Project/File: 310003418

Reference: RM25.372 Parkburn, Compliance review of EMP

Stantec NZ has been engaged by Otago Regional Council (ORC) to conduct an independent technical review of the Environmental Management Plan (EMP) included as part of the Fast Track Consent Application of Fulton Hogan Land Development Ltd, (the applicant) to transform an aggregate quarry into a residential subdivision alongside Lake Dunstan in the Central Otago District.

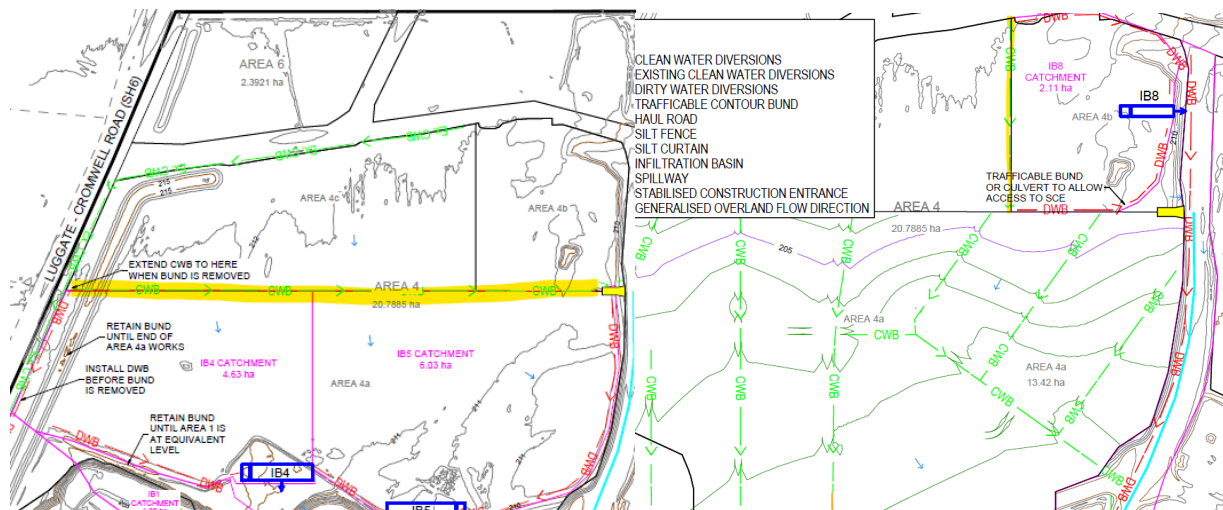
Infiltration basin 6 (IB6), appears to be undersized with area 4c (4.95ha) to be directed towards clean water diversion in area 4a and into IB6 pushing the catchment area closer to 40ha, with most of it shown as clean runoff entering the area of works generating a large amount of runoff to manage. Best practice is to separate clean water upstream of the works. The use of a temporary clean water diversion channel or piping clean water flows across the area of works should be considered.

Example of the issue with catchments are shown below with clean water bund highlighted, changing the catchment areas. Clean water diversion bund installed to completed cutting of area 4a on the left, then moved to direct clean water into area 4a on the right.

4. The applicant should review the clean water catchment areas following the works of Area 1 and produce plans showing the clear and accurate catchments for each infiltration basin.

5. The applicant should review the best practice for clean water management and reduce the need to send over 40ha of water to 1 infiltration basin.
6. The applicant should review the extent of required work to include temporary batters and have this reflected in the catchment sizes, basin positions and water management.
